**2021-B0013**

**BERG INSTRUCTIONAL CENTER (BIC)**  
**1463 SPEECH CLASSROOM UPDATE**

**ADDENDUM NO. 1**

**OCTOBER 12, 2021**

**ATTACHMENT 1**  
**ZIKEN SHOP DRAWING**

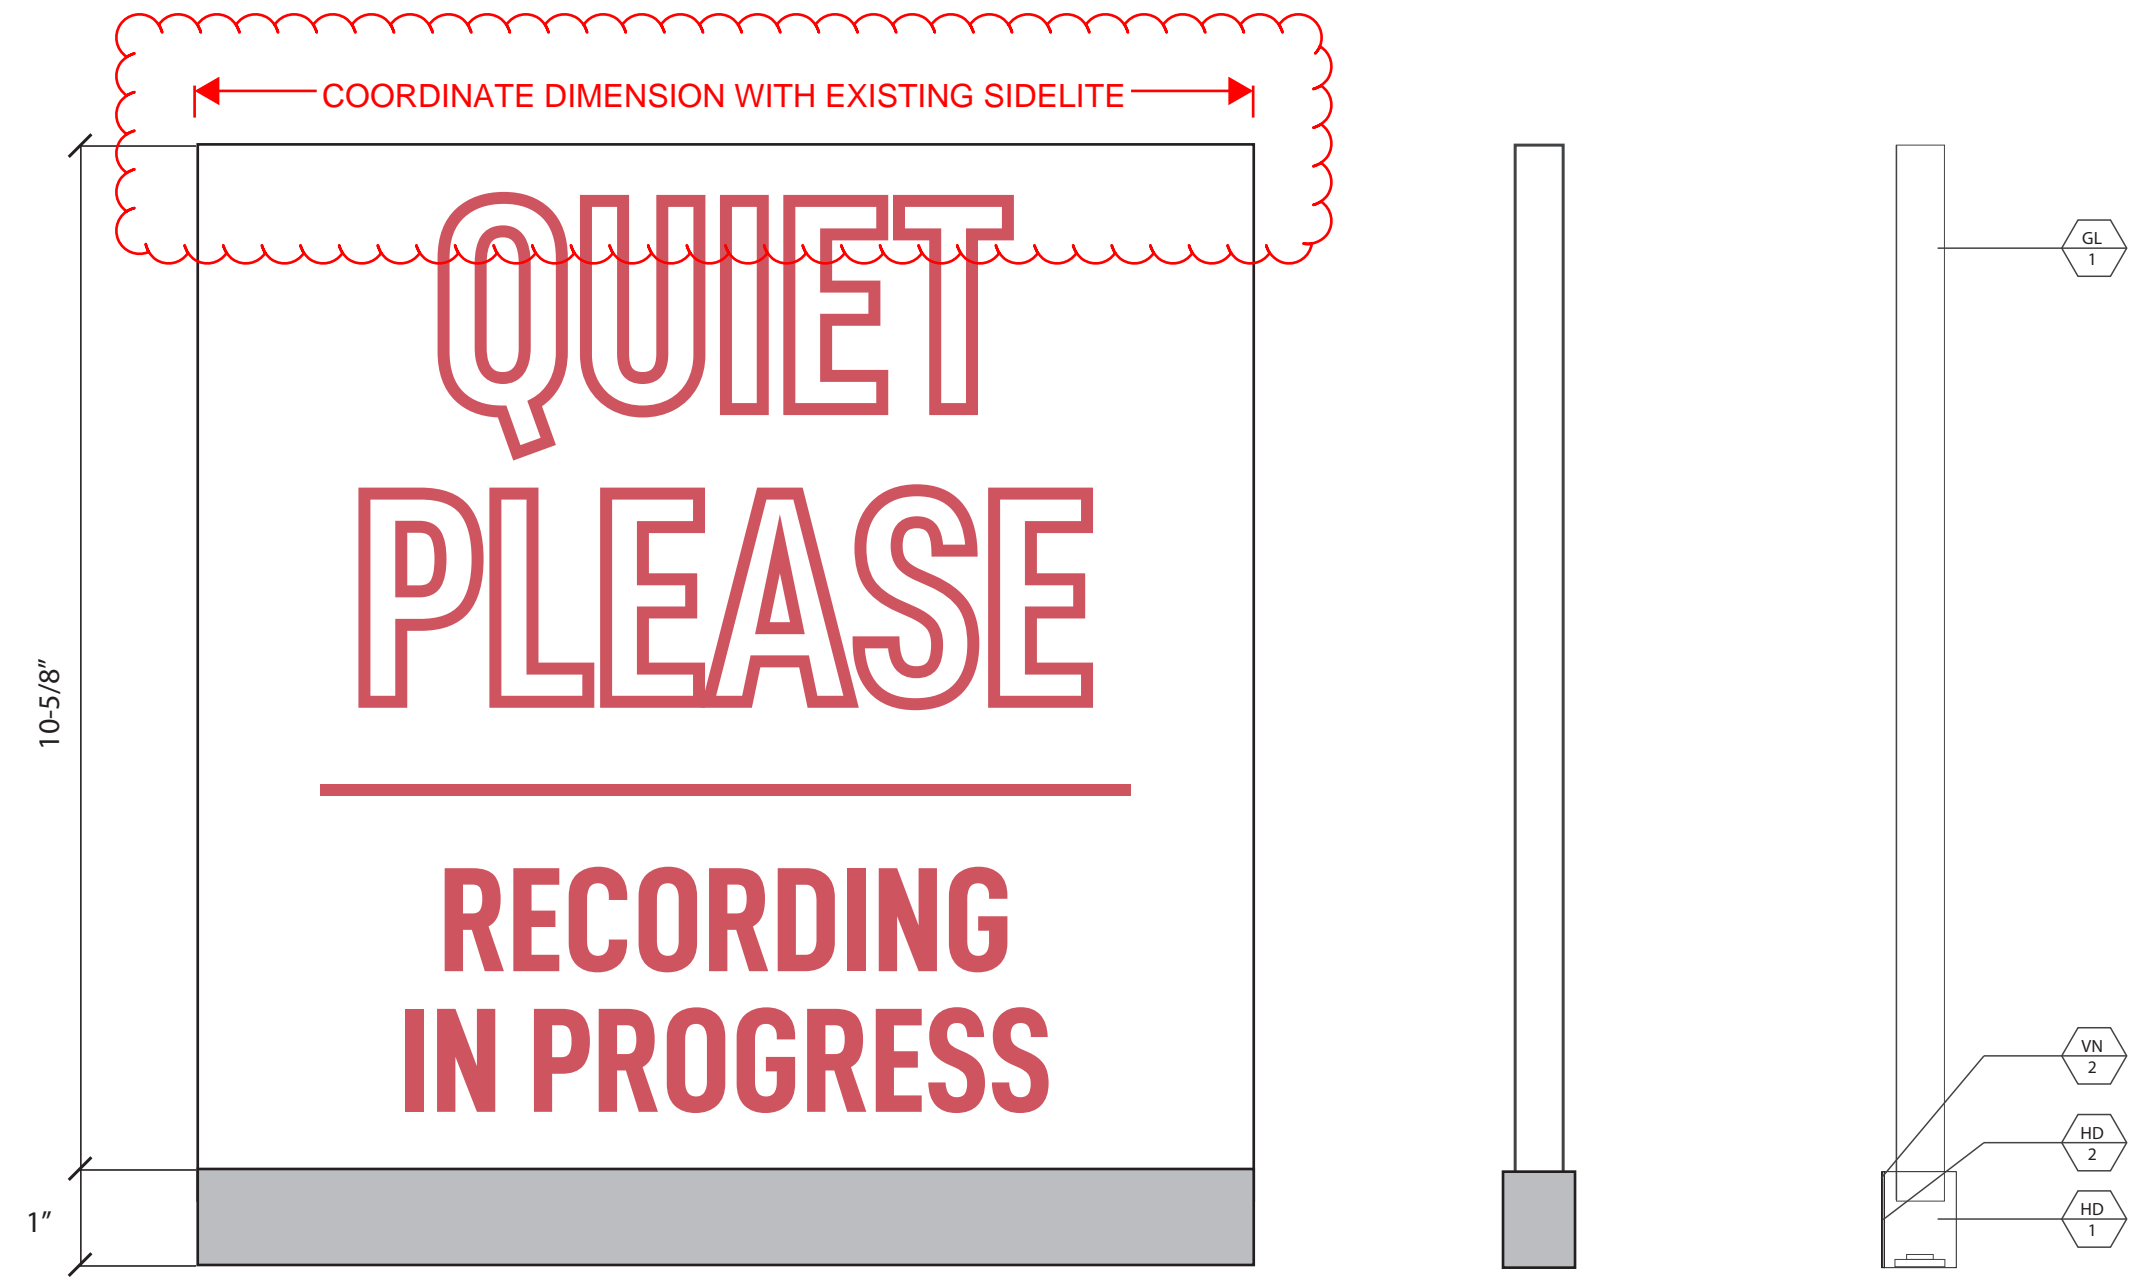
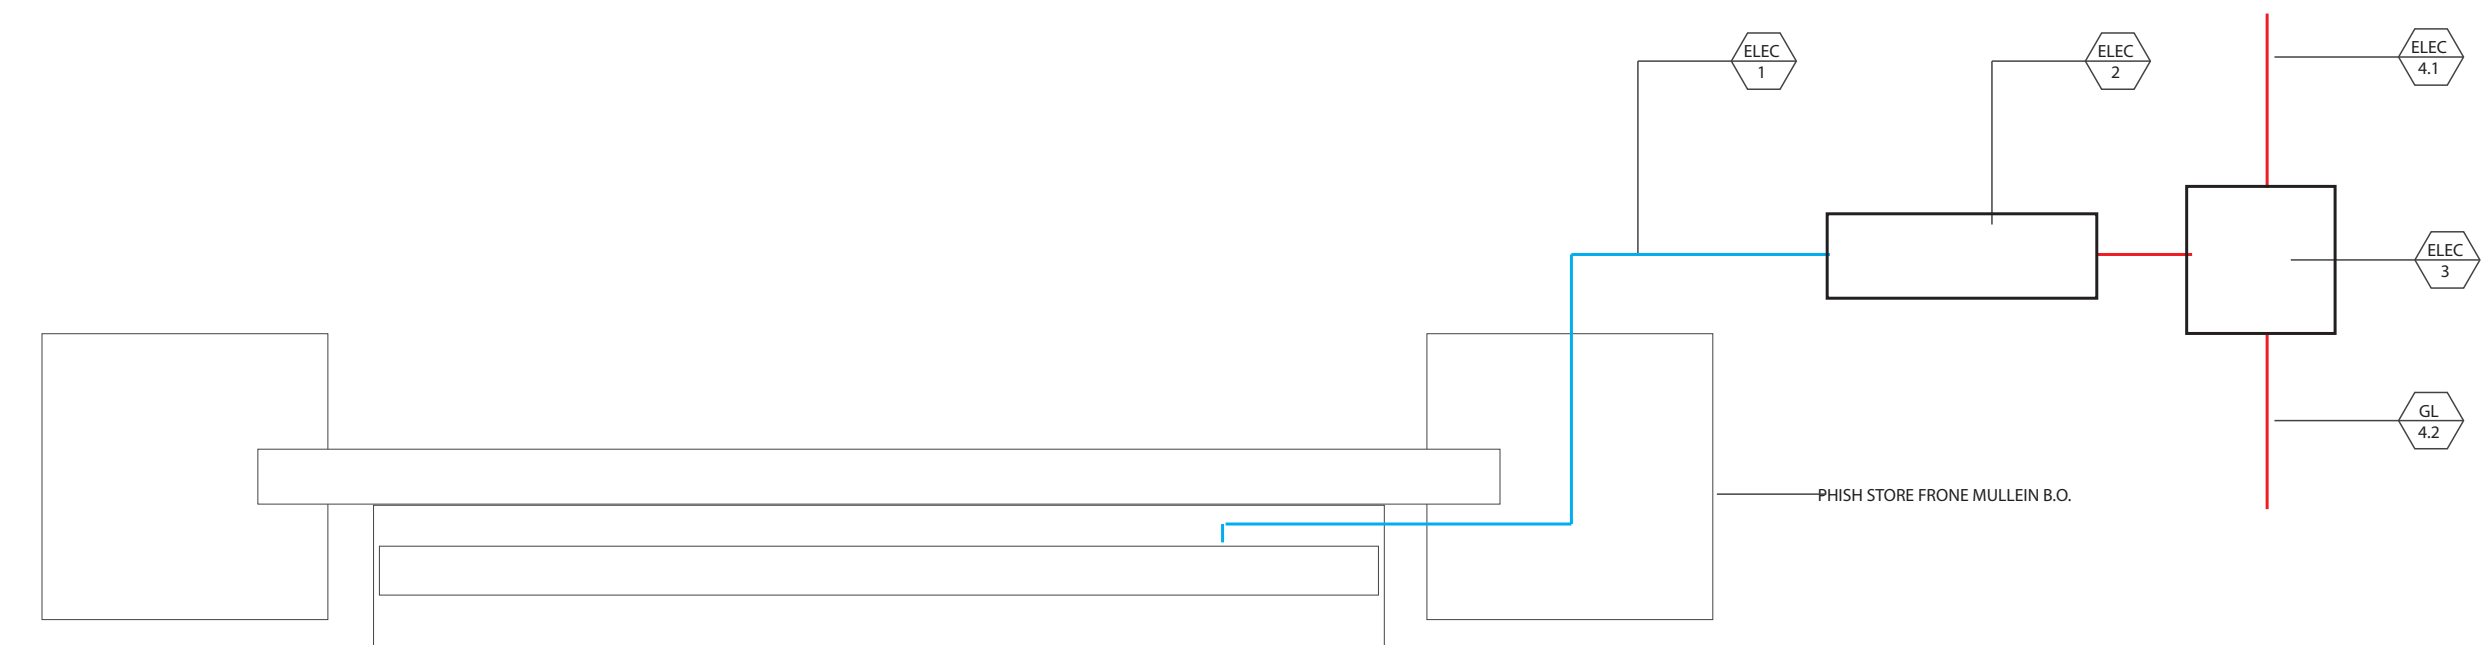
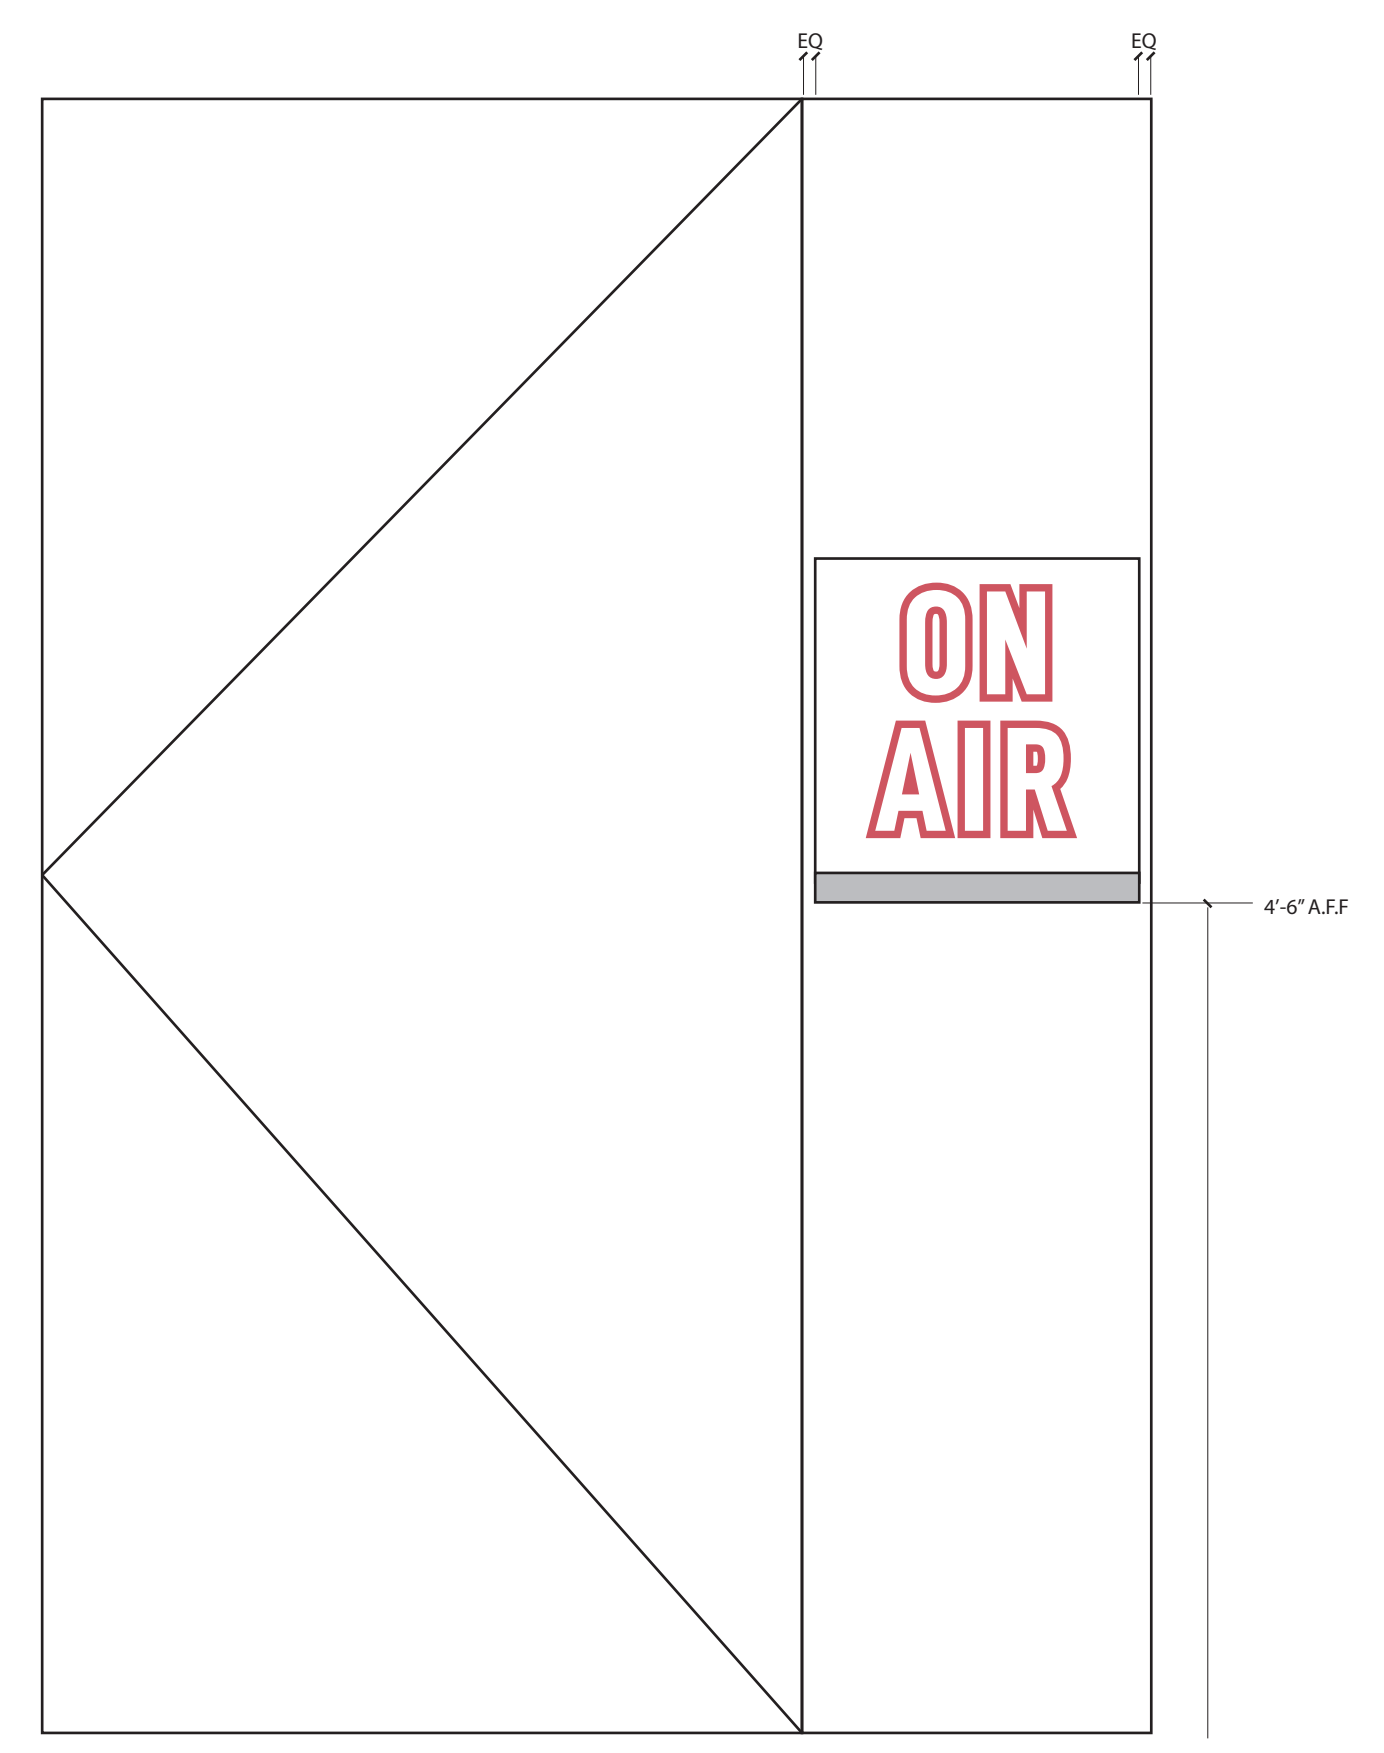
<p>4. Confirm three (3) years software subscription for the Solstice Pods?</p>	<p><b>Yes, a three (3) year subscription</b></p>
<p>5. Is any additional licensing required for the Solstice Pods? i.e. Active Learning</p>	<p><b>No additional licensing required.</b></p>
<p>6. TA0.00 – please provide spec for the Clock system, CLK-01 and CLK-02 – not included in equipment list.</p>	<p><b>CLK-01 is Alzatex DSP254B. CLK-02 is Alzatex KT6X422A.</b></p>
<p>7. Is the recording light (mentioned at the walkthrough) to be included in the AV Scope? If so, please provide spec.</p>	<p><b>The sign, as indicated on the electrical drawings, and further defined in the attached Ziken shop drawing is included in the lump sum bid amount as furnish and install by the bidder.</b></p>
